<b>REFERENCE NO - 21/503713/FULL</b>		
<b>APPLICATION PROPOSAL</b> Erection of a four storey apartment building comprising 14 no. units with associated landscaping and ancillary works including the creation of no. 7 parking spaces, cycle shelter and bins stores, creation of new pedestrian access and use of existing vehicular access from London Road.		
<b>ADDRESS</b> Land on site of former 51 London Road Maidstone Kent ME16 8JE		
<b>RECOMMENDATION</b> GRANT PLANNING PERMISSION subject to conditions		
<b>SUMMARY OF REASONS FOR RECOMMENDATION</b> The proposal would be acceptable with regard to the Local Plan, the NPPF and all other relevant material considerations. All material considerations indicate that planning permission should be approved. Furthermore, the previous reasons for refusal cited by the Inspector have been overcome by the current application.		
<b>REASON FOR REFERRAL TO COMMITTEE</b> Call in request by Cllr Purle. Cllr Purle expressed concern regarding the potential impact on the amenity of the neighbours in Whitchurch Close (to the rear/southwest of the development proposal) and the occupiers of No.49 to the southeast. In addition, he expressed concern relating to th

Figs. 1 and 2. Front and side elevations of the previous application (referenced 18/506333/FULL) which was refused and subsequently dismissed at appeal.

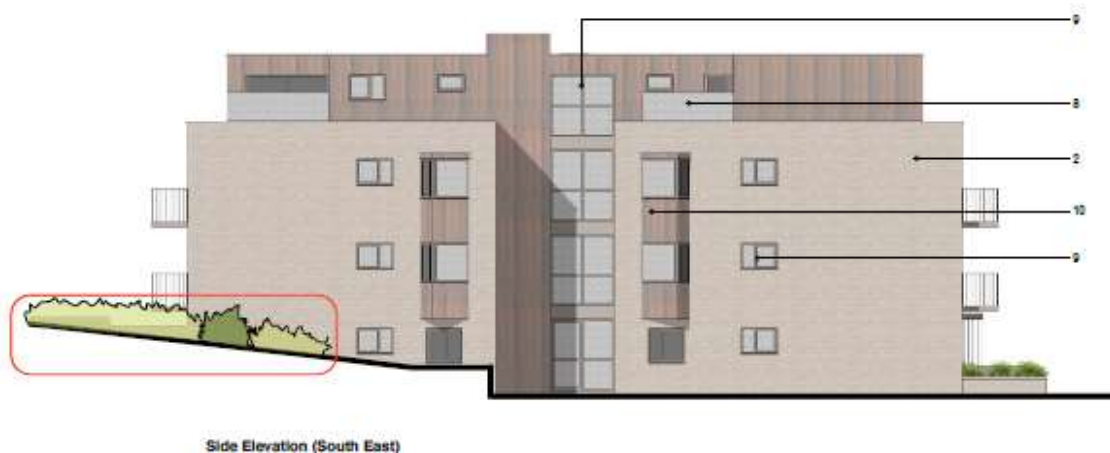
- 7.06 The previously refused application (reference 18/506333/FULL) which was dismissed at appeal comprised a double gable frontage with an eaves height of 8.7 metres and a ridge height of 11.4 metres, approximately 2.0 metres taller than the neighbouring property at No 49. Undercroft parking was incorporated within the building with a height of 2.2 metres. In terms of footprint, the development proposal had a width of 17 metres and a depth of 35.3 metres.

- 7.07 In paras 12 and 14 (see Appendix 1) of the appeal decision dated 24<sup>th</sup> January 2020 the Inspector commented that, 'The design and scale of the front elevation of the proposed building, and its set-back position, would not be out of keeping with the

Section through development proposal showing relationship to the boundary with No 49.

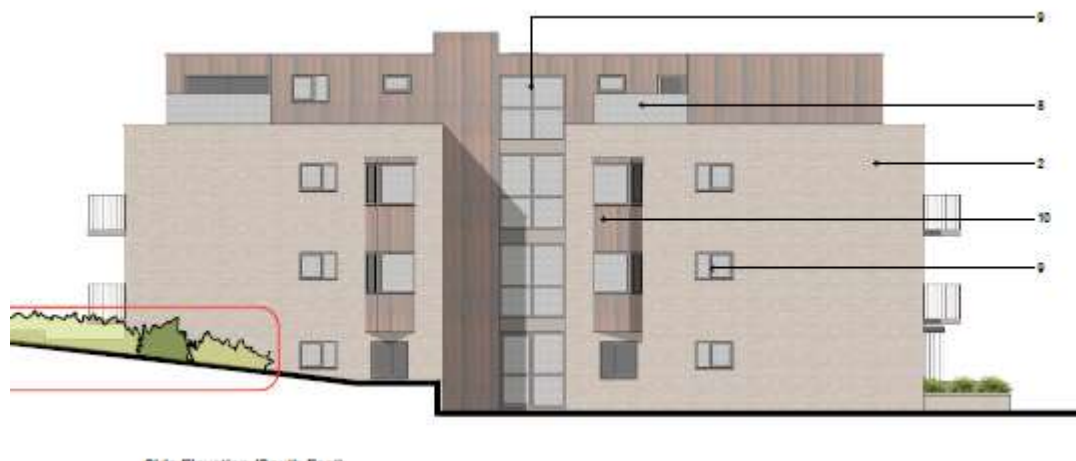
7.18 No 49 London Road has several windows on the north-west (flank wall) of the building. These comprise kitchen and conservatory windows at ground floor level, and bathroom and study windows at first floor level. In addition to this, there is an annexe to the rear of No 49 London Road which has three windows on the flank wall which (the occupant has confirmed) all serve a living space. There is a 1.8 metre high wall on the boundary of this property. The reduction in the height, siting and depth of the proposed four storey building, with a combination of vastly reduced kitchen/bathroom and landing fenestrations on each floor (all of which would be obscure glazed) and two oriel bedroom windows on the first floor and second floors of the 25 metre flank elevation, would be a marked improvement on the previous scheme.

Fig 8 South-eastern elevation of the current scheme

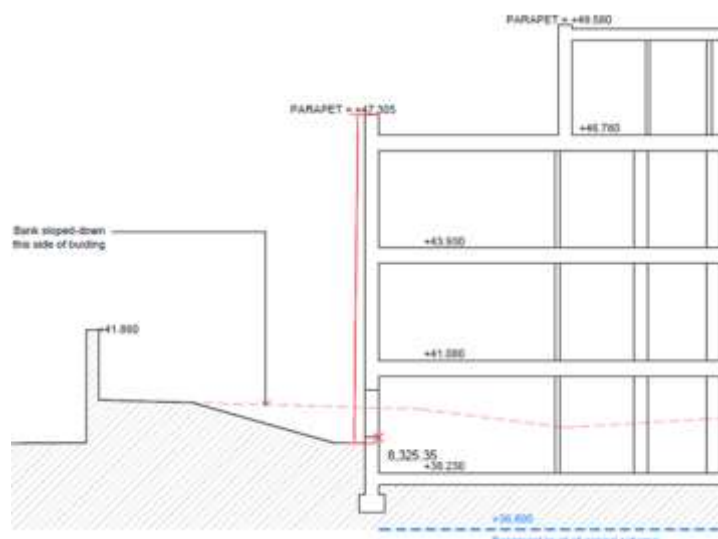
7.17 As can be seen in Fig 6, the bulk, massing and density of the development has been substantially reduced from the previously refused scheme. The setback can be clearly demonstrated, and this would clearly improve the outlook of the neighbouring property at No 49. Furthermore, the reduction in the amount of fenestration on the southeast boundary (the side of the flat roofed terraces) would result in significantly less over-looking. The majority of the windows are secondary to the living areas, and the bedroom windows are of an oriel design which would have oblique views as set out in Fig 8. Fig 9 shows the previously refused scheme for

comparison purposes. The terraces and fenestration have been clearly marked on the drawings as being obscure glazed, and a condition to ensure that this would remain the case has been added. In addition, a condition relating to details of the screening on the south-eastern side of the balconies which can also be seen on either end of the south-eastern elevation as set out on Fig 8 has also been requested by condition.

Fig 10 Section through the proposed development showing the relationship of the building to the south-eastern boundary.

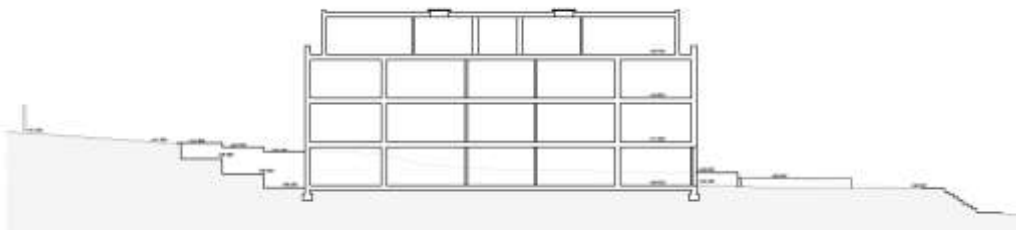
7.19 The reduced height of the proposed building and its siting over 8.5 metres away from the south-eastern boundary would also be an improvement on the previous scheme. The fourth floor has been set in from the flank wall an additional 7.3 metres resulting in the bulk of the building closest to the neighbour having a height of 8.0 metres. (See Fig 10 above) These measures, in addition to the reduction in the depth of the building by 10 metres (which would comprise a 3 metre setback from the principal elevation of the front footprint of No 49 and the rear elevation of the development proposal being brought into line with the rear elevation of No 49) would result in it overcoming the loss of outlook set out in the previous appeal decision.
